Design Response Conference 8/25/2009

Building A Massing & Material Modulation

Notes from 8/31/09 DRB Meeting

**Master Plan and Design Guidelines
Page PO-5 – 8. Design Intent**

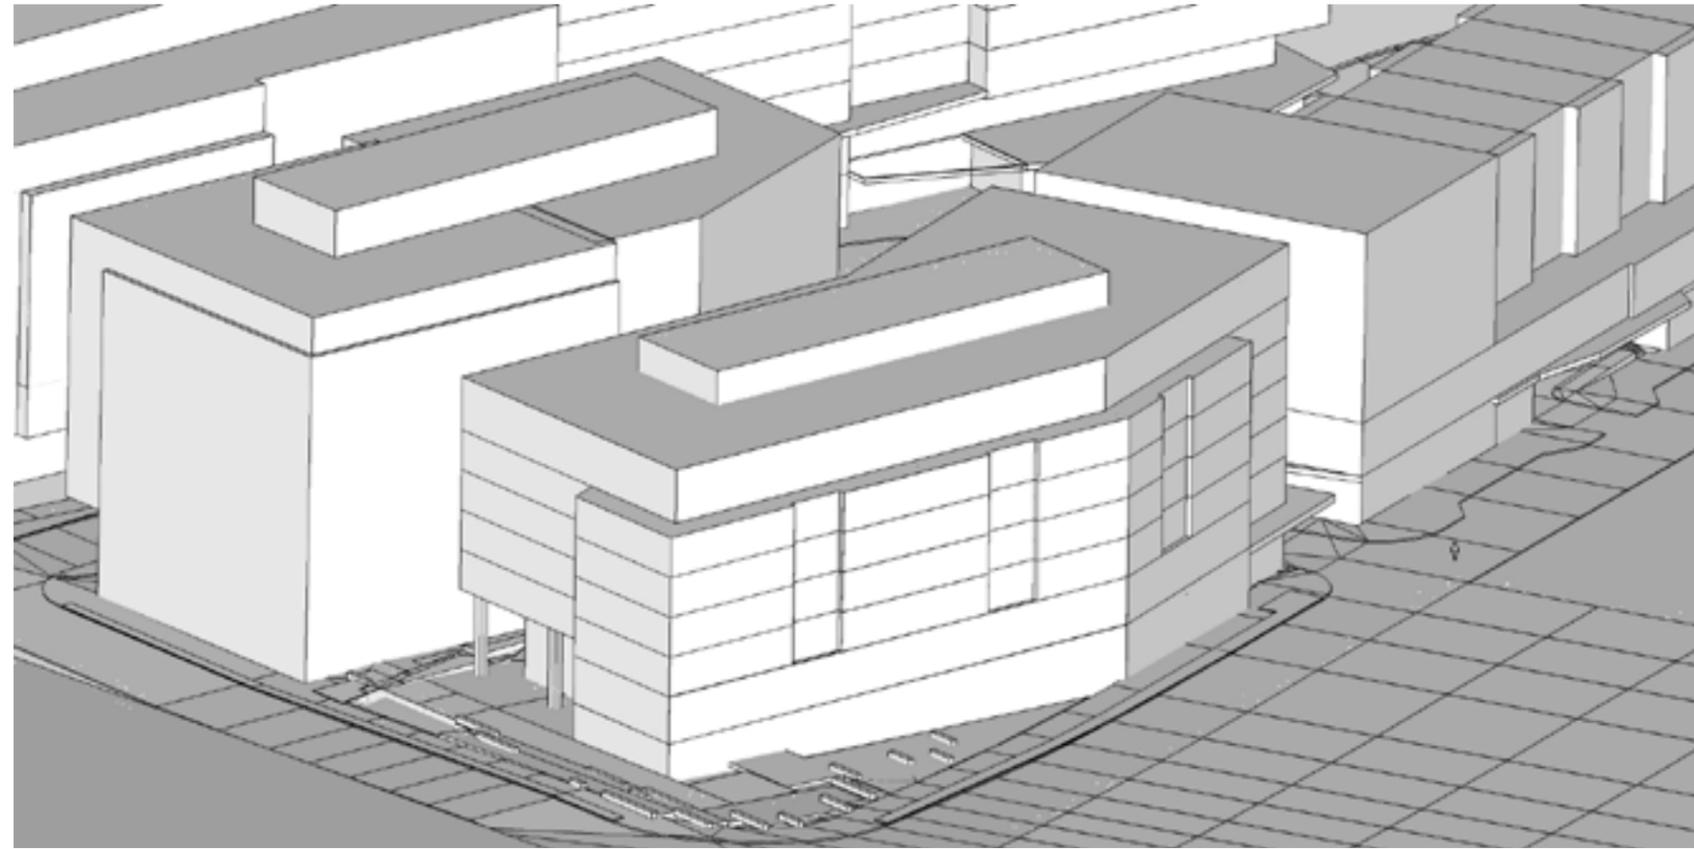
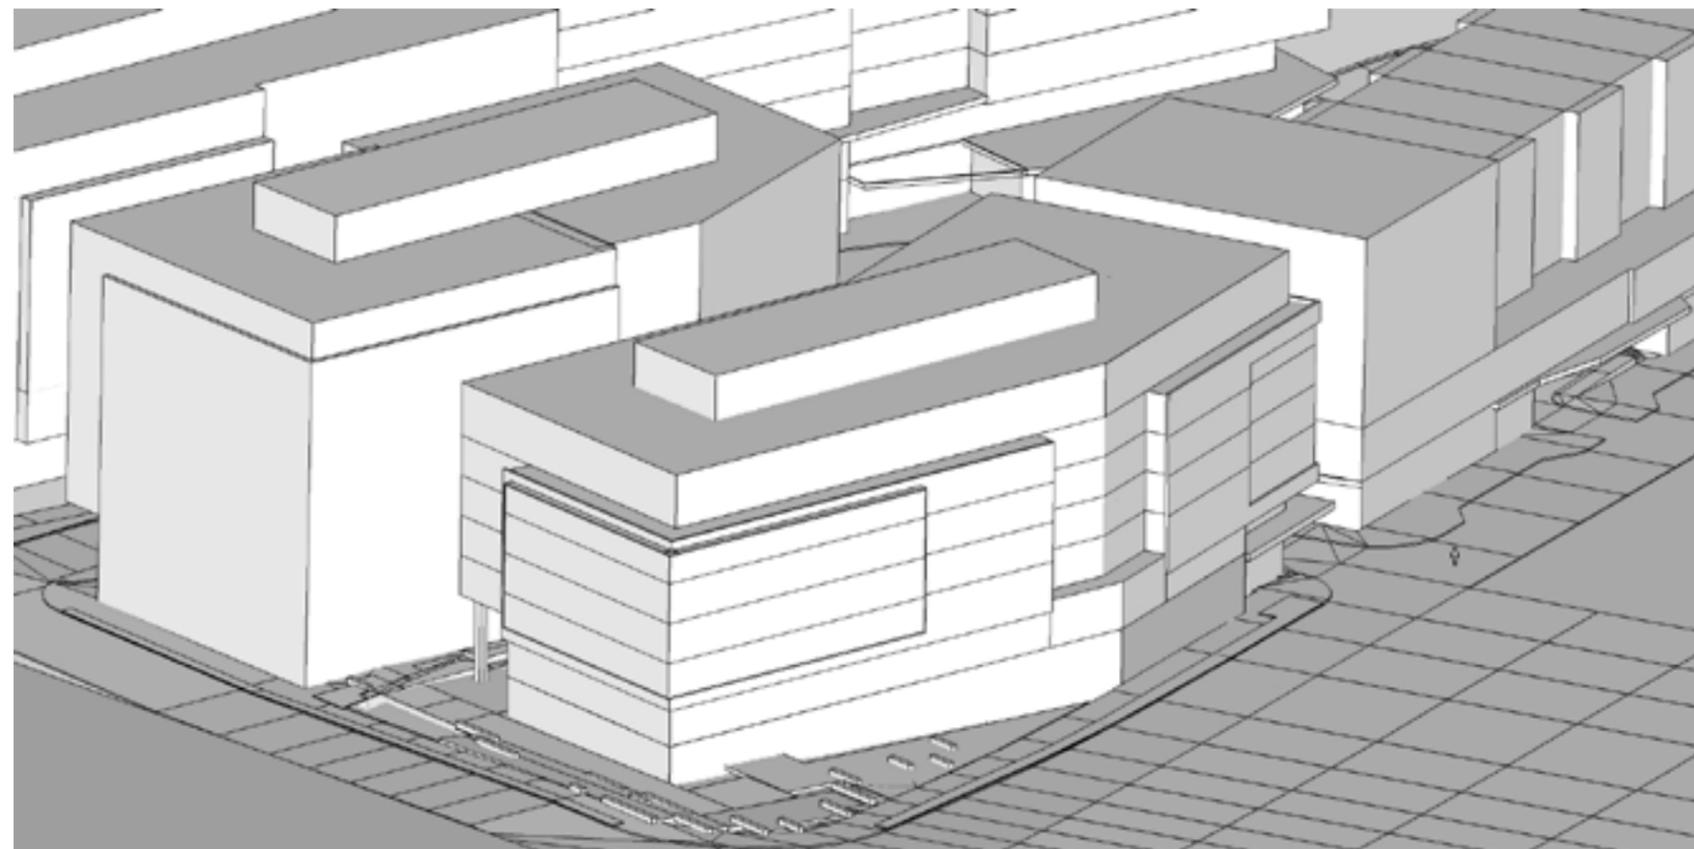
DRB comment: Create visual interest along the street.

Response: It is our intent to create a rich visual environment for pedestrians. Further information that describes this will be shown as Building A develops.

**Master Plan and Design Guidelines
Page PO-5 – 8. Design Intent**

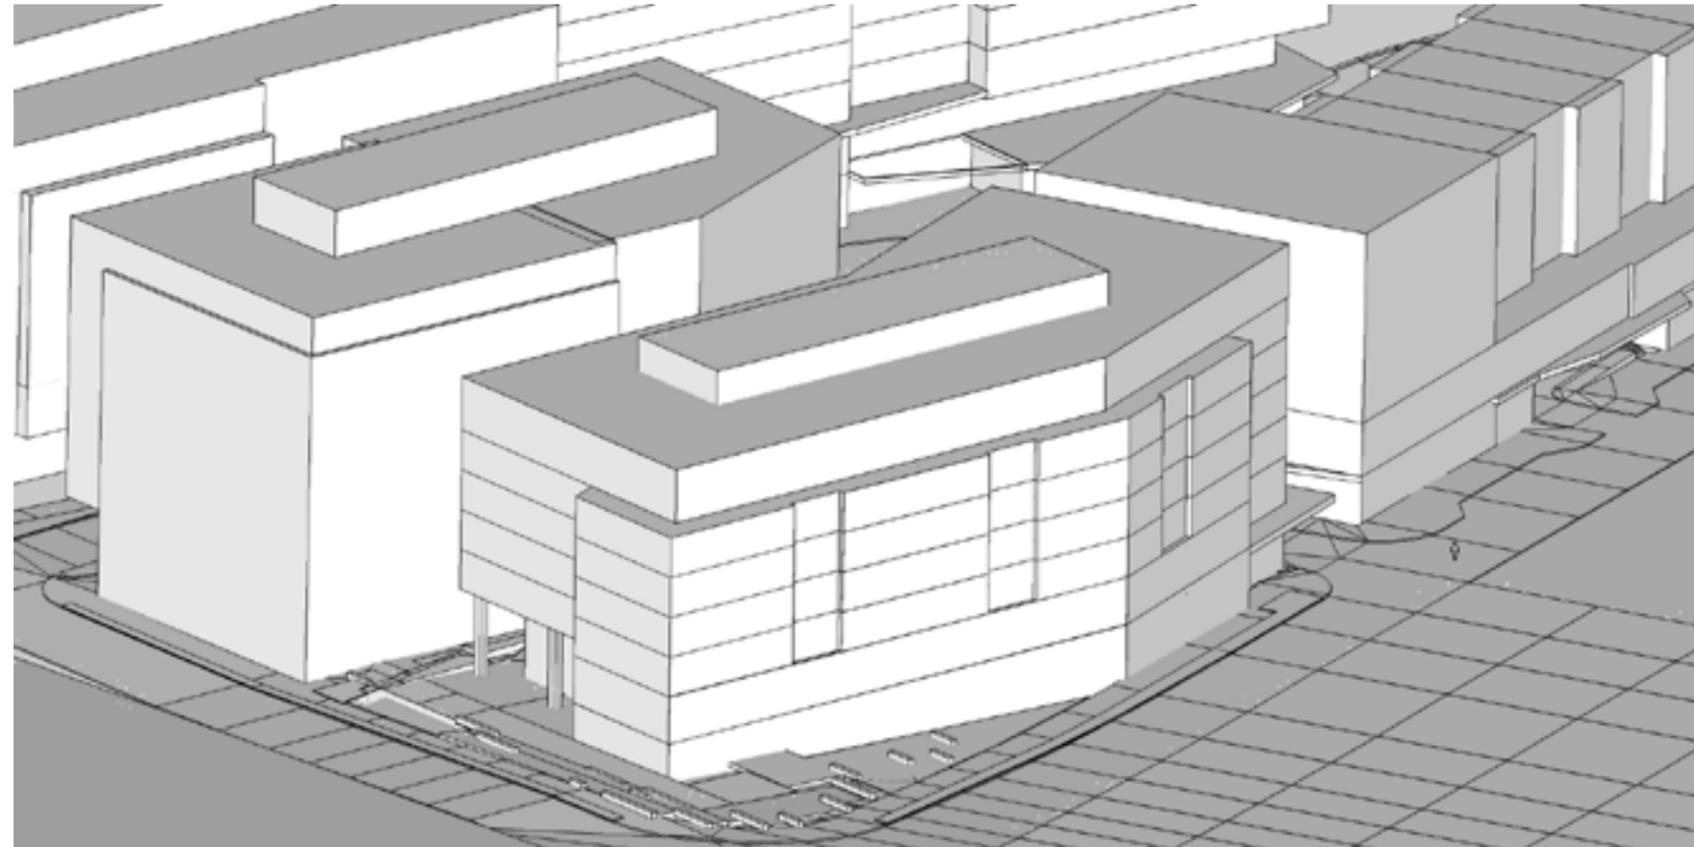
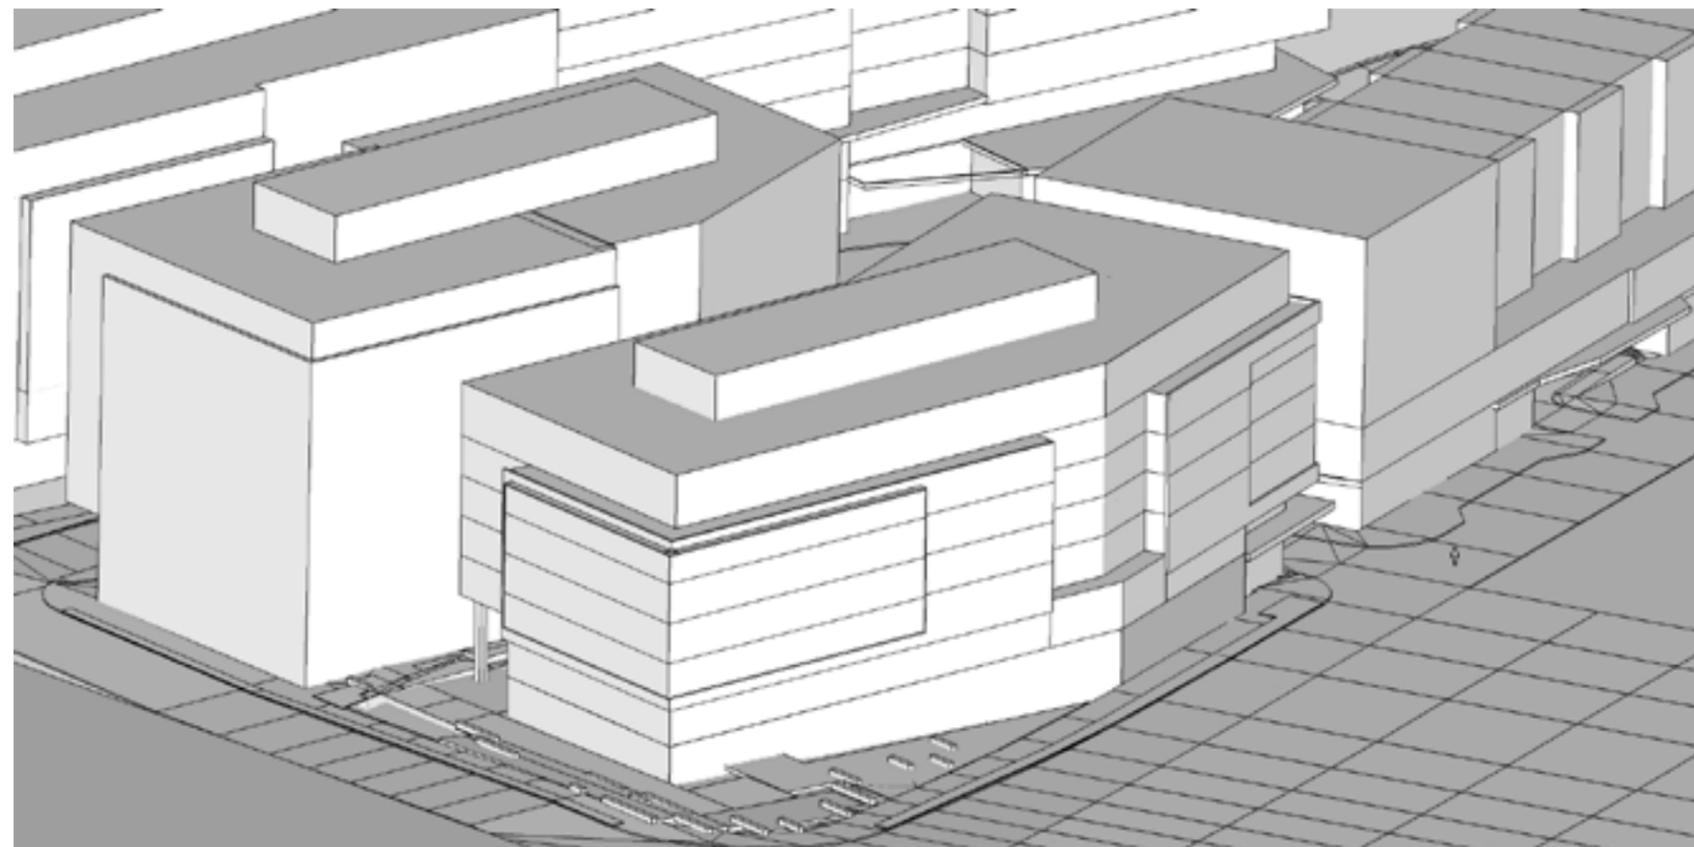
DRB comment: Consider scale, massing and detail of individual buildings and express human-scale, detailed street level building façades.

Response: Horizontal modulation of the facade has been used to break down the mass of Building A. Further development of Building A will reveal the detail and articulation strategies employed to provide appropriate scale.

**Master Plan and Design Guidelines
Page DG – 20 – All Districts: Bldg. Design**

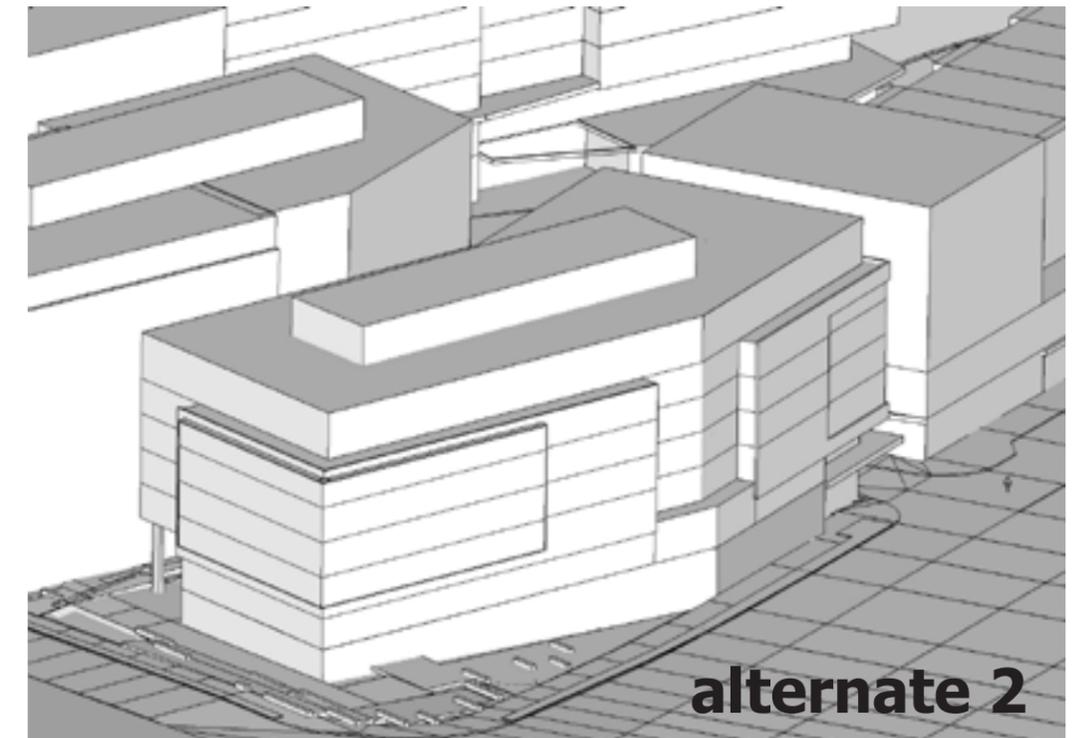
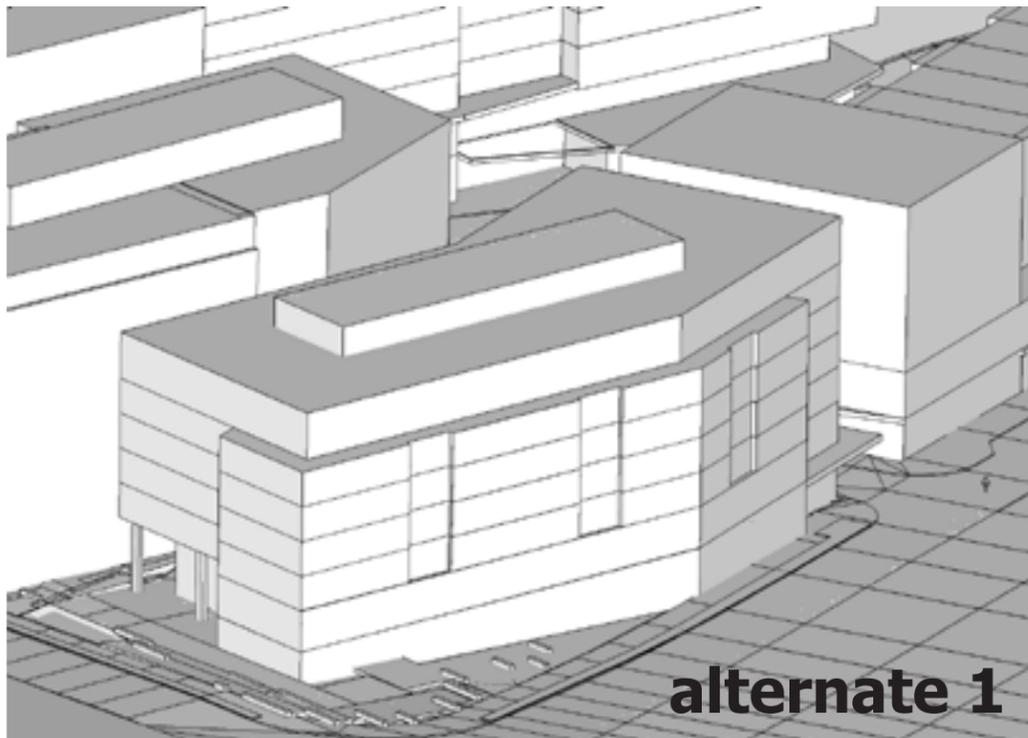
DRB comment: Responsive to context of surrounding environment? Need more information on this. Don't see how buildings are responsive to surrounding environment and buildings. Buildings can respond to the context in a different way. This is still an issue, but not one of the most critical. It is difficult because there is not one existing style in the area. Need to speak the same language – not necessarily the same vocabulary. May not be about the materials, may be about the massing.

Response: Our approach to the issue of context has not been to respond to immediately adjacent buildings since historicizing styles and materials such as Dryvit ❶ are not appropriate for the quality we envision at Park Place. However, the larger Kirkland context offers cues that we have responded to, such as:

- a. Diversity of materials, including brick, stone, metal and glass of different types and styles, which are reflected in our materials palette; ❷
- b. A variety of scales of buildings and textures, which are an inspiration for the 'weave' concept; ❸
- c. An established village retail environment that is the inspiration for our retail base design. ❹
- d. A smaller scale of façade articulation that we have picked up on in the revised Building A design. ❺

**Master Plan and Design Guidelines
Page DG – 20 – All Districts: Bldg. Design**

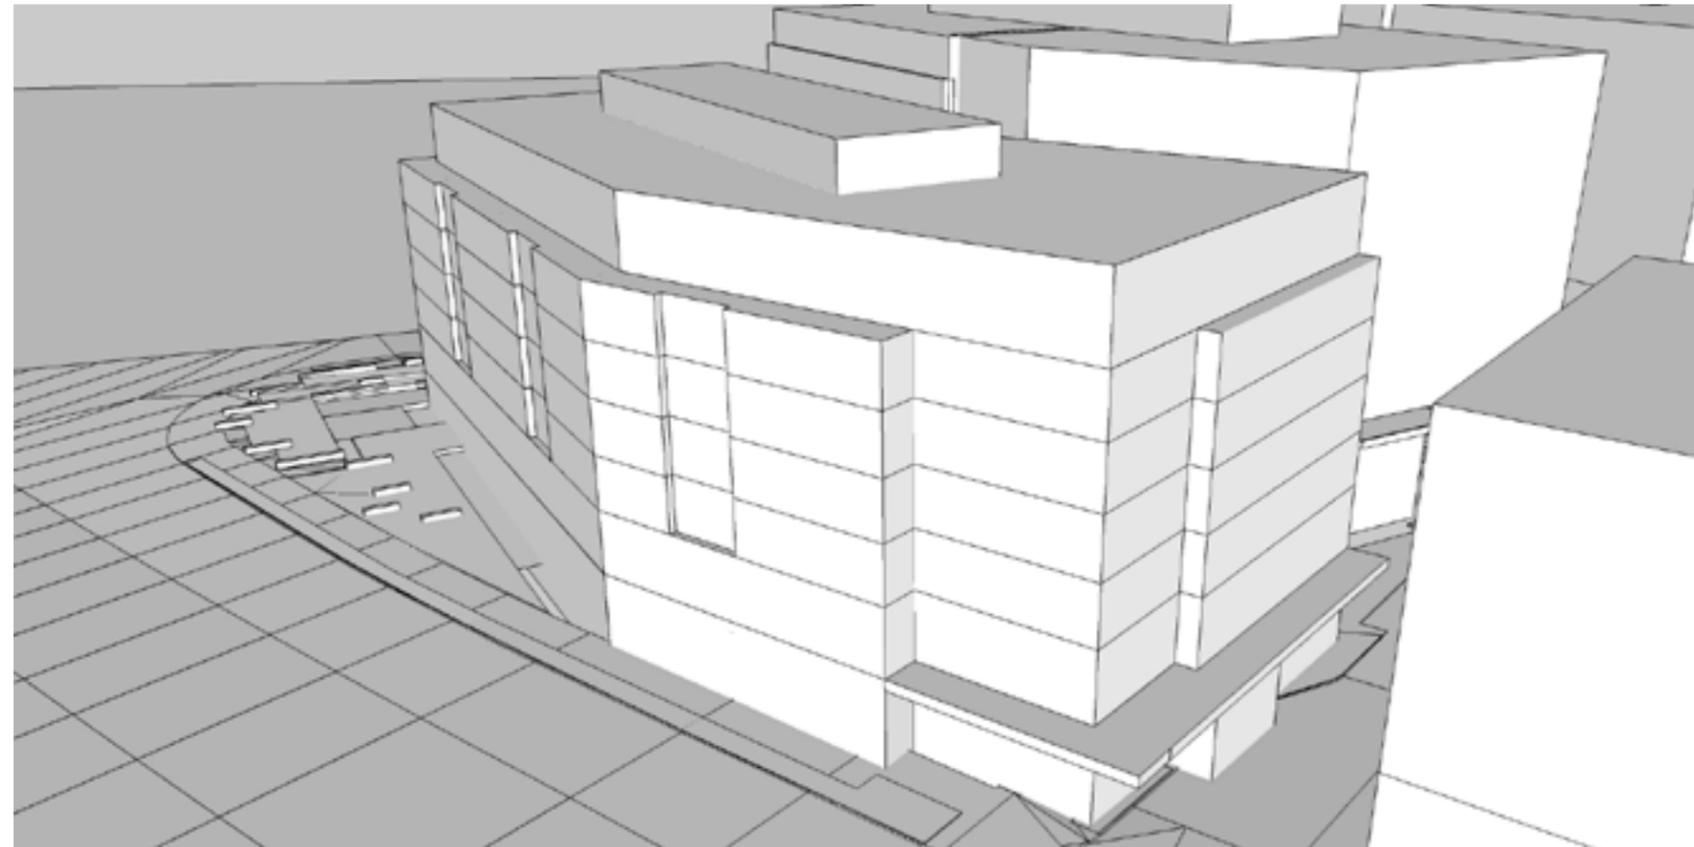
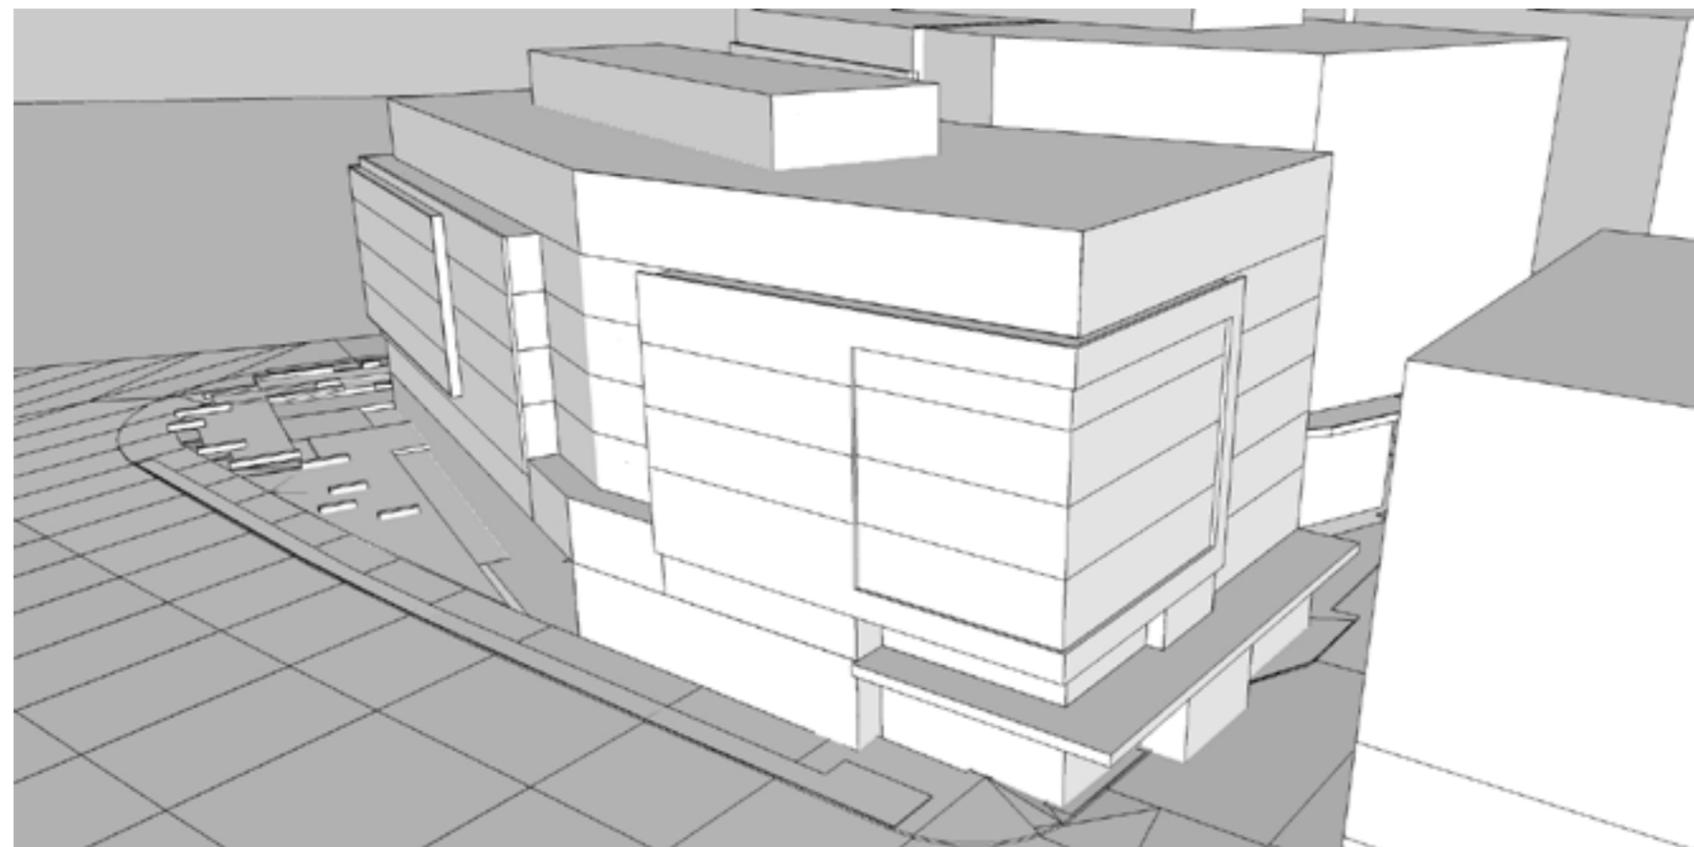
DRB comment: Distinguish building base. The gasket addresses this, but is still a concern in some areas.

Response: The revised design for Building A takes a more direct approach to the establishment of a strong building base. The 'gasket' is still a feature of the design, but starts farther west than before, allowing building A to sit more solidly on the ground, much like buildings B and C on the 6th Street side.
